FERGUSON TOWNSHIP PLANNING COMMISSION REGULAR MEETING AGENDA Monday, January 13, 2020 6:00 PM

SUBJECT: West Cherry Lane Multi Use Building
Preliminary/Final Land Development Plan
Third Review (ES-405)

As requested, I have reviewed the 'West Cherry Lane Multi Use Building Preliminary/Final Land Development Plan' prepared by Penn Terra Engineering, dated September 12, 2019 and last revised December 3, 2019 for conformity to the Township Ordinances. Following are comments from my review.

**RE: West Cherry Lane Multi Use Building Preliminary/Final Land Development Plan
Stormwater Management Site Plan and Lighting Plan Review**

OVERALL LAND
DEVELOPMENT
PLAN

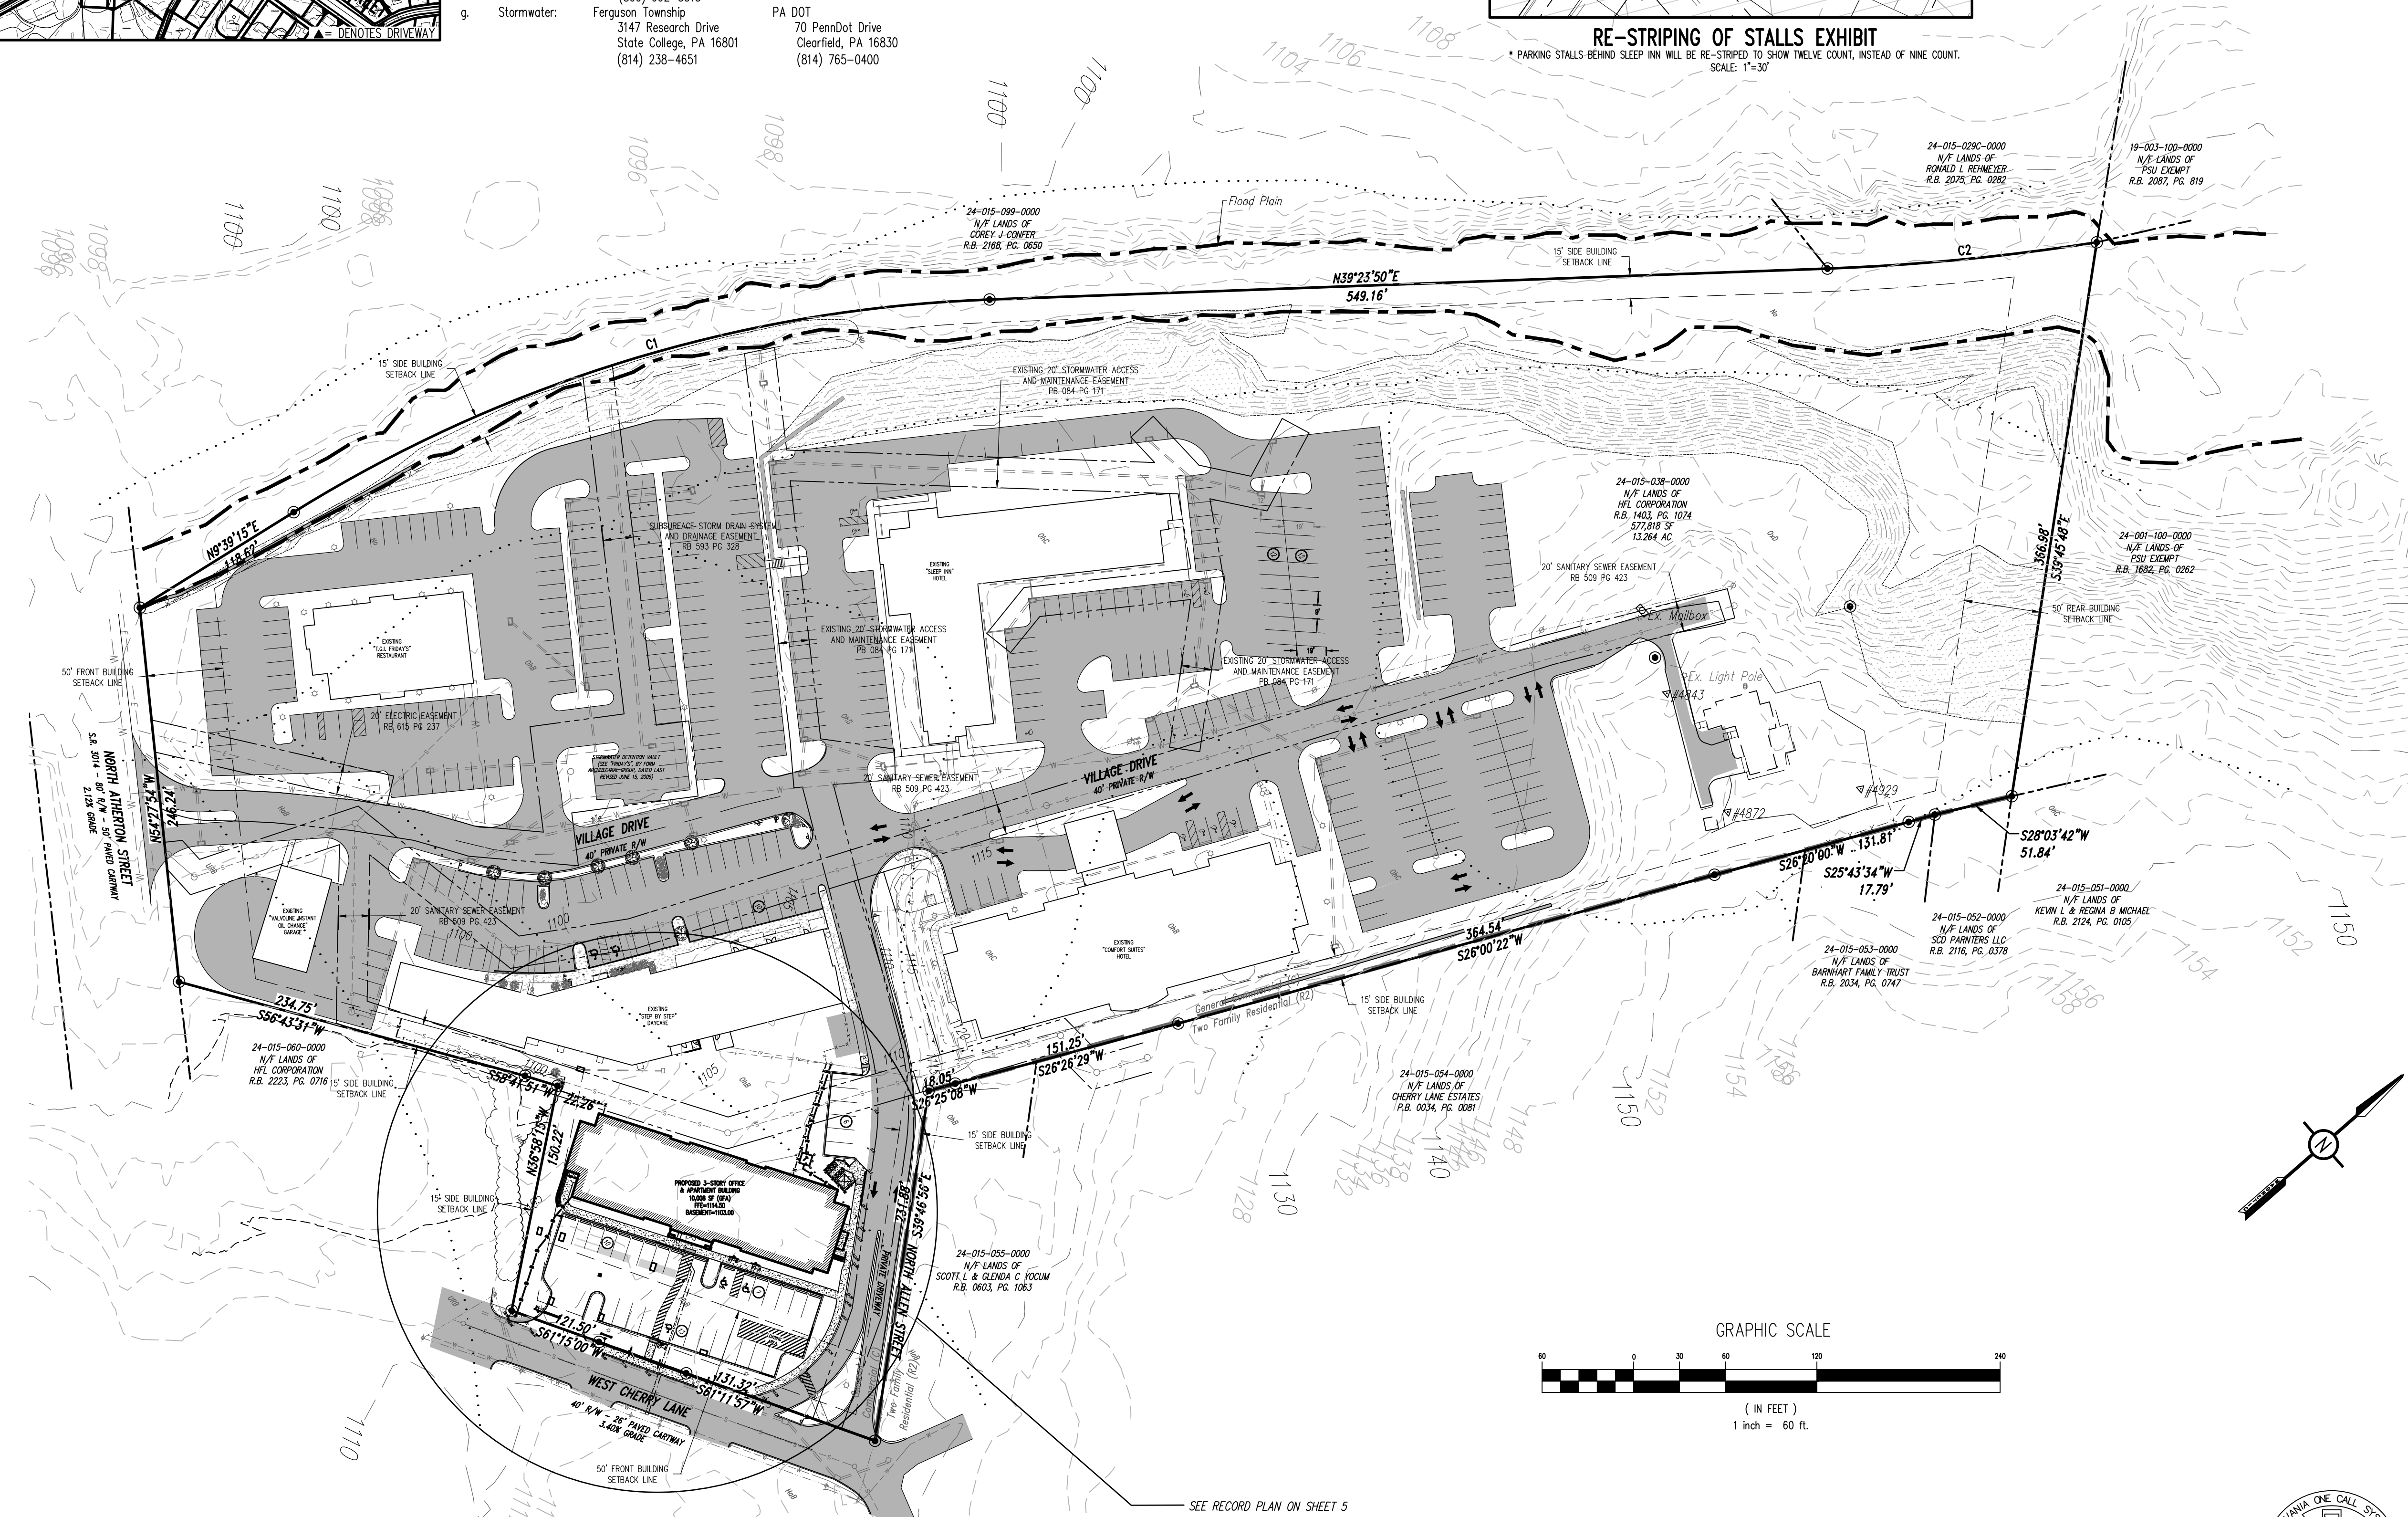
1. On sheets 4 and 5, the deed reference noted on the plan for this parcel will need to be revised once the consolidated deed is recorded. (Ch 22-401.1.A (1)(c)) **Not resolved, pending lot consolidation recording.**

DETENTION SYSTEM CROSS SECTION
NOT TO SCALE

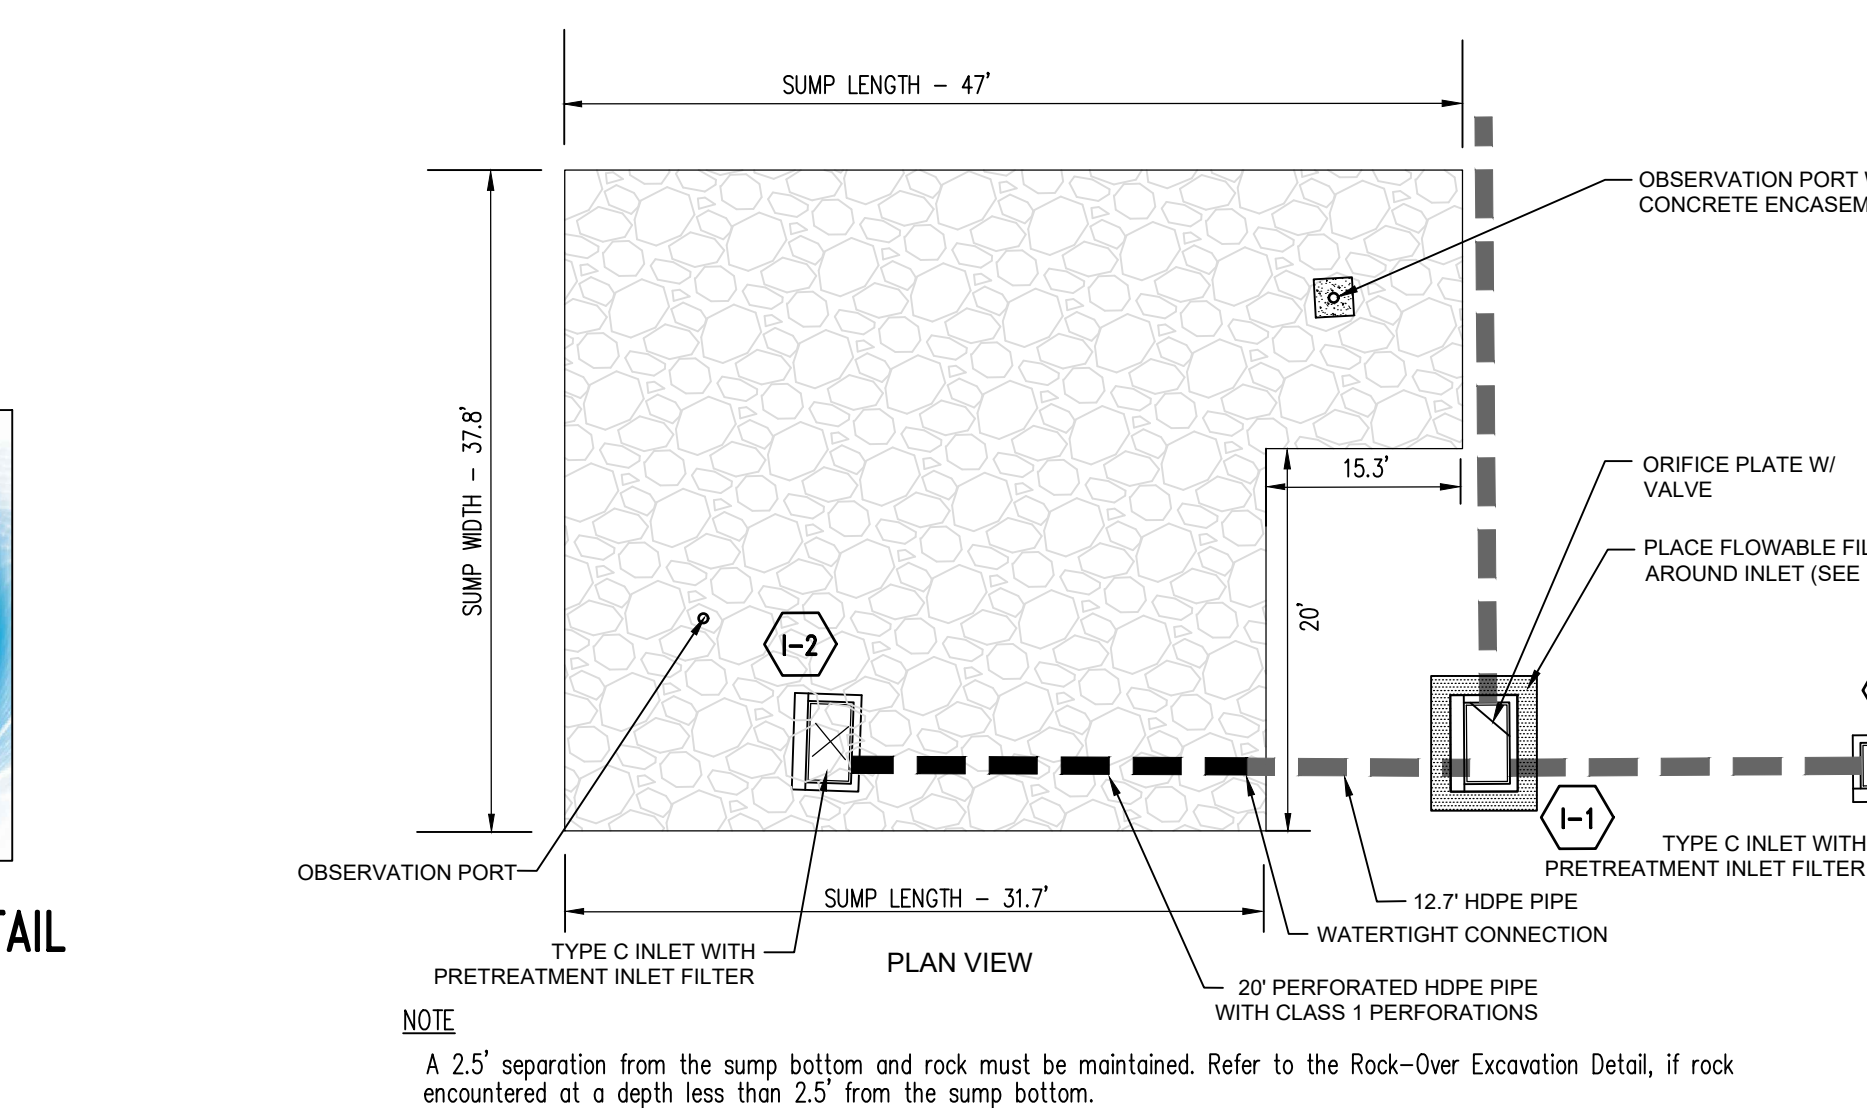
- e. *The underground detention system should have another inlet with steps provided on the east side of the system for inspection and maintenance. The 36" manhole riser might be acceptable if appropriate steps are provided in the structure. **Not resolved. Access to the underground detention facility is still limited and will require confined space entry protocol for both maintenance and inspection. Is there an alternative design that would allow for inspection of the system without the need for confined space entry protocol? This will add costs to the owner monthly to inspect the system and requires additional effort for the Township to perform inspections. Applicant indicated that additional cleanouts can be added accordingly where required. This does not address the comment.***

INFILTRATION SUMP DETAIL
NOT TO SCALE

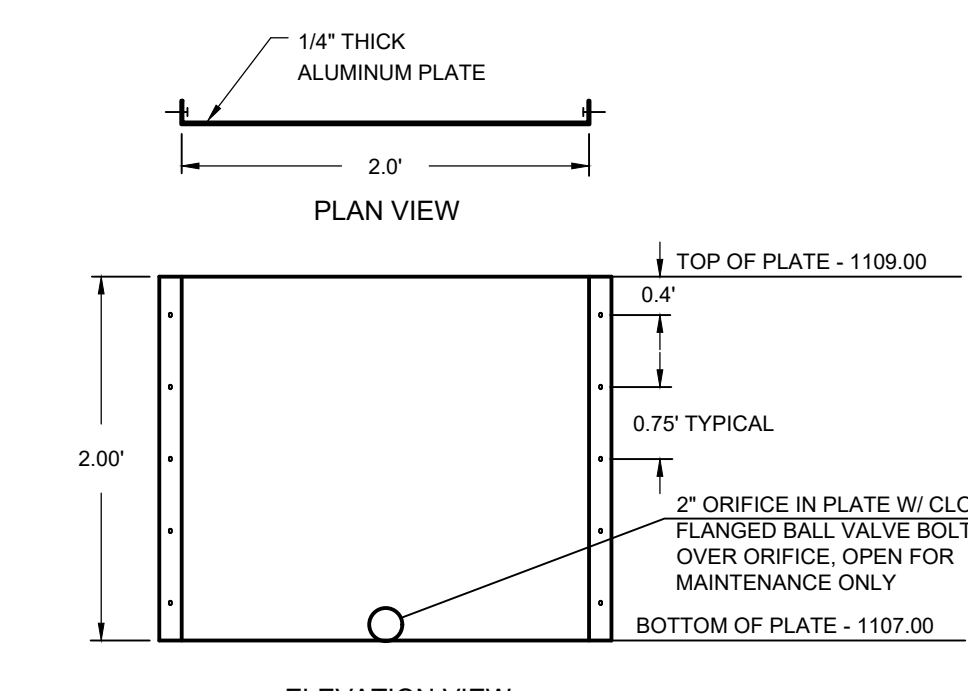
- h. *It appears that the infiltration sump may drain into the detention basin without requiring the stormwater to infiltrate into the soils, but I cannot clearly understand how the system is supposed to function. Not resolved. The orifice plate detail indicates the bottom of the plate is at elevation 1107.0. The inlet table indicates the invert of the inlet is elevation 1106.5. There is a gap from the bottom of the plate to the inlet invert of 0.5 feet. **Resolved.***

17. Provide design details and notes identifying how the water is to enter the stone sump.

November 15, 2019: Additional notes and details needed. As currently designed, it appears that water from the sump will be able to drain from the sump to I-1 and ultimately to the HDEP detention area through the stone material in the trenches and around the base of inlet I-1. Provide details illustrating how this migration of flow will be controlled. Also provide

December 16, 2019: Comment partially addressed. It appears that water from the stone sump can still bleed into stone bedding in the storm pipe trench from I-1 to the 48” storage pipe.
